Subject: MHI's Responses to NRC's Request for Additional Information Technical Report CFD Analysis for Advanced Accumulator MUAP-09025

**MHI's Responses to NRC's Request
for Additional Information**

**Technical Report CFD Analysis for Advanced Accumulator
MUAP-09025**

RAI for CFD Analyses for Advanced Accumulator, MUAP-09025-P (R0)

Figure 1-1 Boundary Pressure Setup Method in 1/2 scale Model

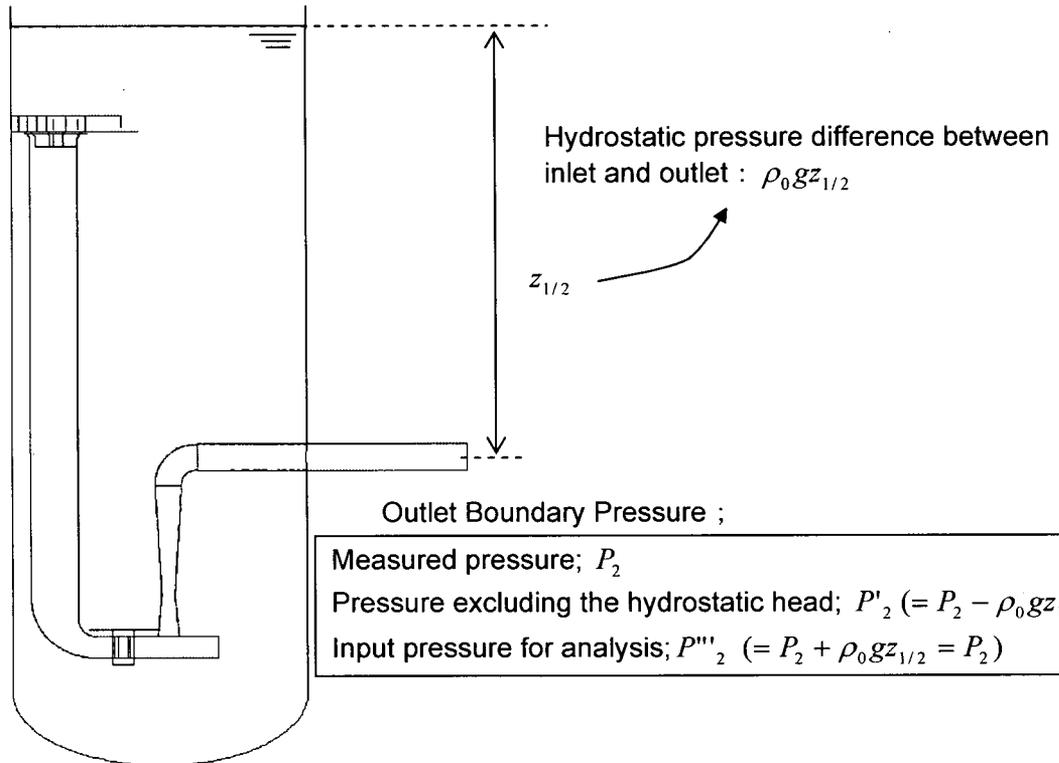
- c) In the boundary condition section (Sect. 3.4, Note 2) it is mentioned that the outlet

boundary conditions for the full scale is specified by subtracting the hydraulic pressure equivalent of height difference between the outlets for full scale and half scale facilities. For the 1/2 scale facility, the measured pressure is applied as outlet boundary condition without any correction.

- Please explain why this correction is needed for full scale facility calculations?
 - What are the differences in vertical dimensions of full scale and half scale facilities?
- d) Please show the difference in pressure values for the inlet and exit boundaries after the corrections were made for different cases.

The outlet pipe elevation in the 1/1 scale model is higher than that in the 1/2 scale model. Hydraulic head caused by the elevation difference between the tank water surface and the center of outlet pipe in 1/2 scale model is different than that in the 1/1 scale model. Thus, same boundary pressure values as that in the 1/2 scale model have been specified in the 1/1 scale model in order to match the inlet/outlet differential pressure (which is the driving force of the flow) in the 1/2 scale model. Figure 1-1 explains this in detail.

Inlet Boundary Pressure:

Measured pressure; P_1
 Pressure excluding the hydrostatic head; $P'_1 (= P_1)$
 Input pressure for analysis; $P''_1 (= P'_1 + \rho_0 g z_{1/2})$

Outlet Boundary Pressure ;

Measured pressure; P_2
 Pressure excluding the hydrostatic head; $P'_2 (= P_2 - \rho_0 g z_{1/2})$
 Input pressure for analysis; $P'''_2 (= P_2 + \rho_0 g z_{1/2} = P_2)$

Note: Since "Gravity Term" is included into Pressure Term in the calculation, same inlet/outlet boundary pressure values as that in the 1/2 scale model have been specified in the 1/1 scale model
